**TO:** Casey Adragna, Adragna Architecture  
**FROM:** Elizabeth Steward, Associate Planner- Development Review  
**DATE:** 10/27/25  
**SUBJECT:** Douglas 234 Multitenant, Site Plan  
Review Comments 02

SITE PLAN  
**HORSE CREEK COMMERCIAL**  
 LOT 10B, DOUGLAS 234 FILING NO. 6, AMENDMENT 2  
 A PORTION OF THE SW 1/4, SE 1/4, SECTION 29, T6S, R66W, 6TH P.M.  
 TOWN OF PARKER, COUNTY OF DOUGLAS, STATE OF COLORADO

COVER SHEET  
 DOUGLAS 234 FILING NO. 6, AMD. 2  
 JOB NO. 24020  
 DATE: OCTOBER 3, 2025  
 SHEET C1

**SITE DETAILS**  
 DOUGAS 234 FILING NO. 6, AMD. 2  
 DATE: FEBRUARY 17, 2025

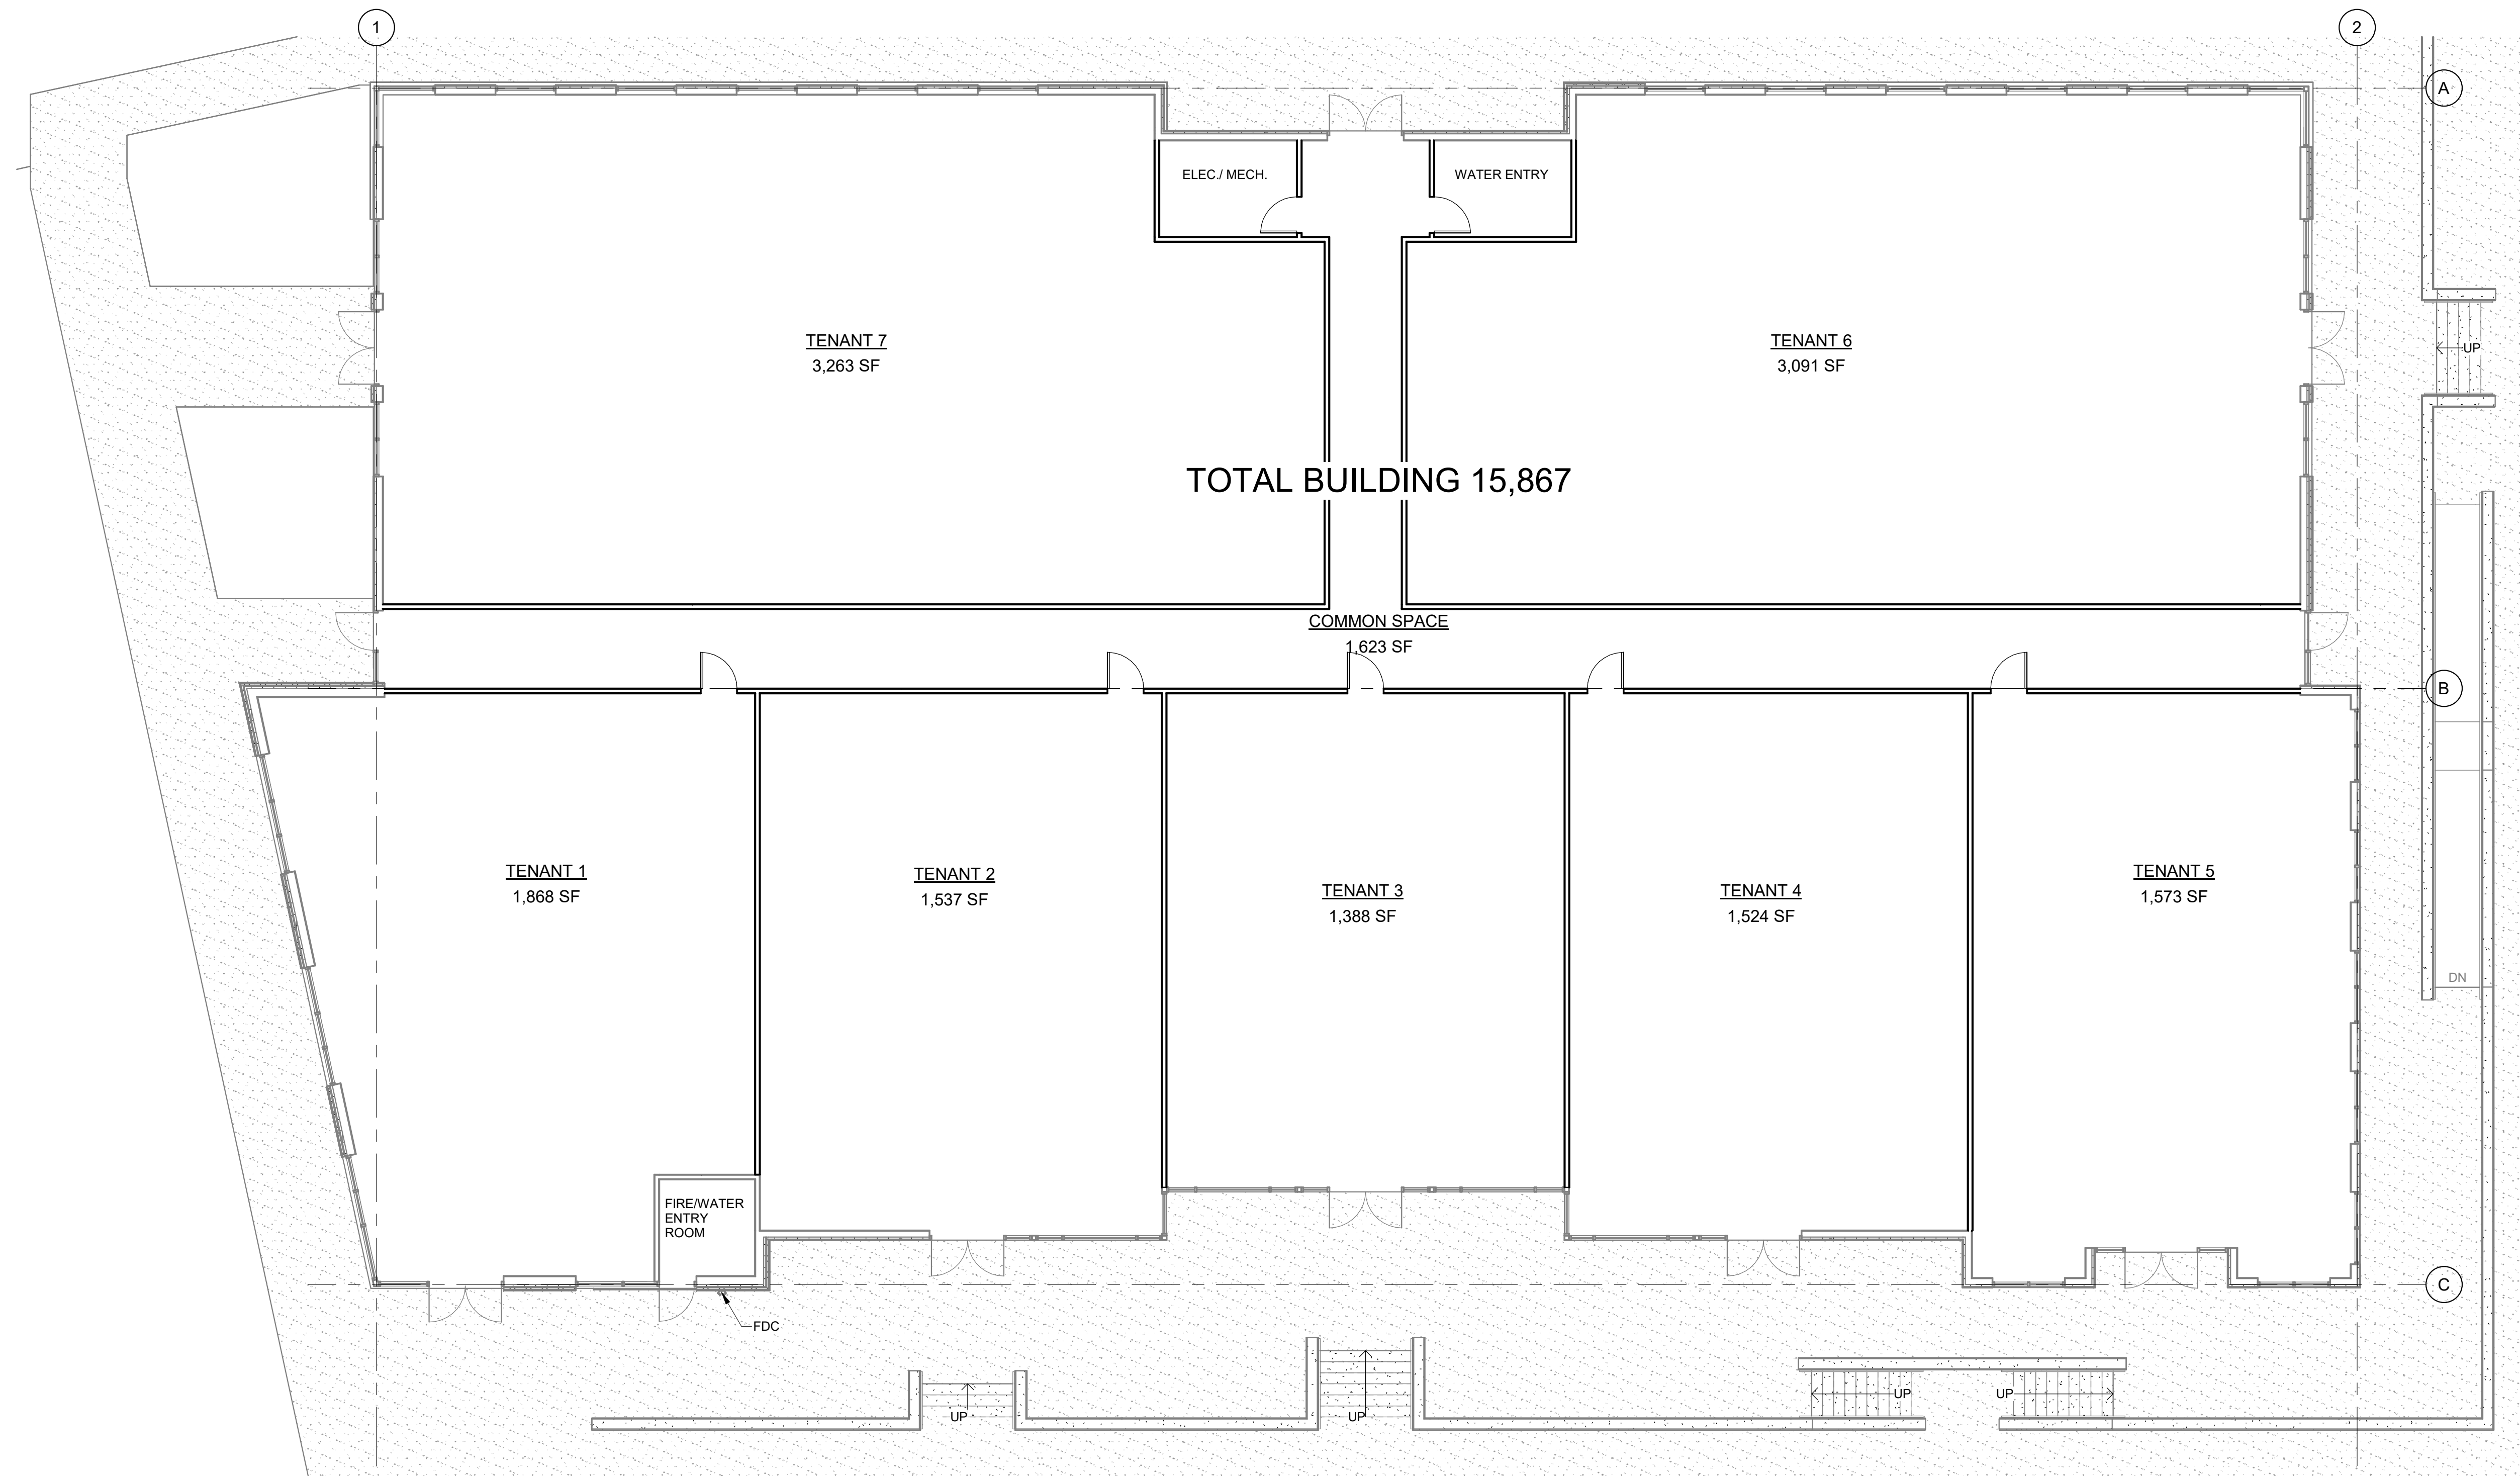
Spec needed for railings-  
 color and material  
 Guardrail detail has been added.
